ADDENDUM NO. 2

Bid Number 21-04-20

Jacobs Project No.: D3282100

Antioch Road Elevated Water Storage Tank

04/2021	ADDENDUM 2	NO.	DATE	DR	REVISION	CHK	BY	APVD
				S. TATMAN			S. TATMAN	J. NESSL
							S. JERNIGAN

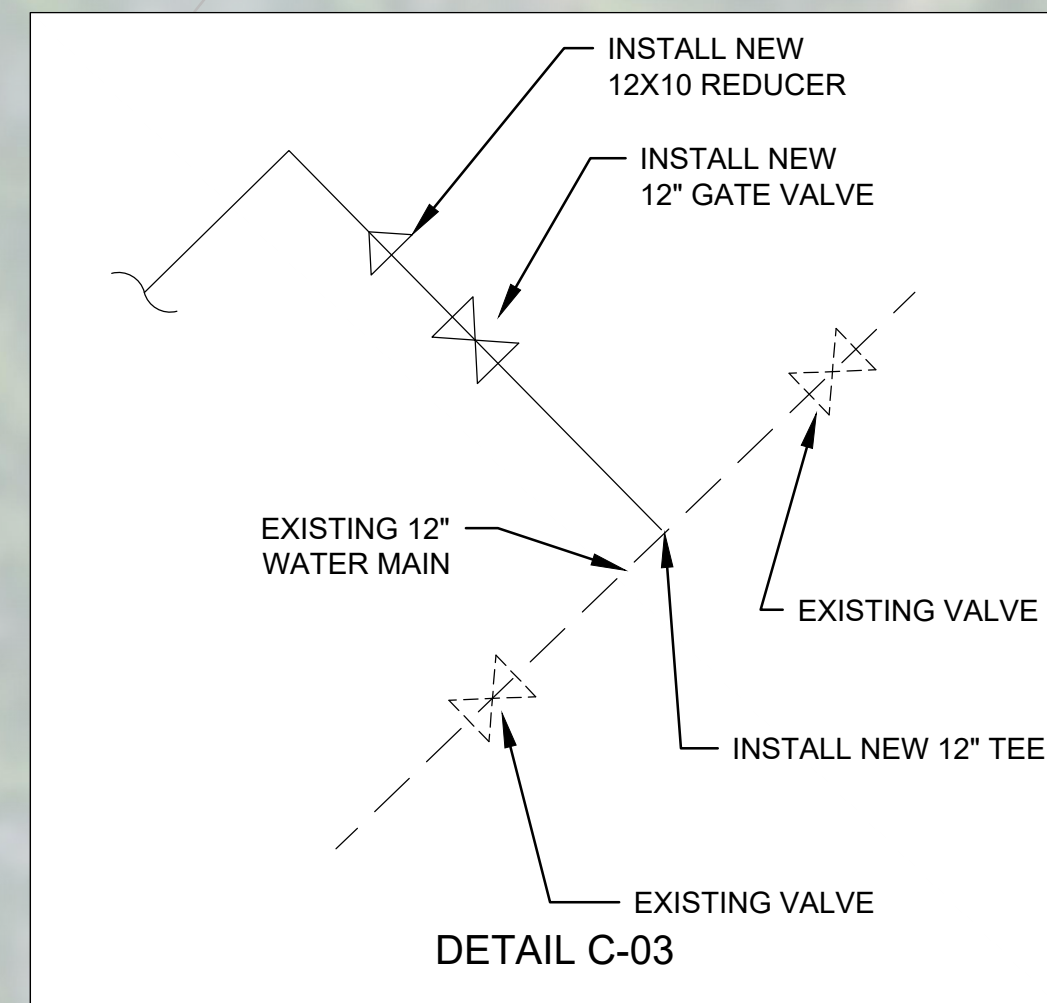
1. Sheet C-03 is hereby modified and reissued. A slot has been added to the stormwater outfall structure and the water line route has been modified near Well 8.
2. Sheet C-04 is hereby modified and reissued. The water line route has been modified near Well 8.
3. Sheet GA-01 is hereby added to the bid documents. This sheet provides the general arrangement information for the water spheroid style tank.
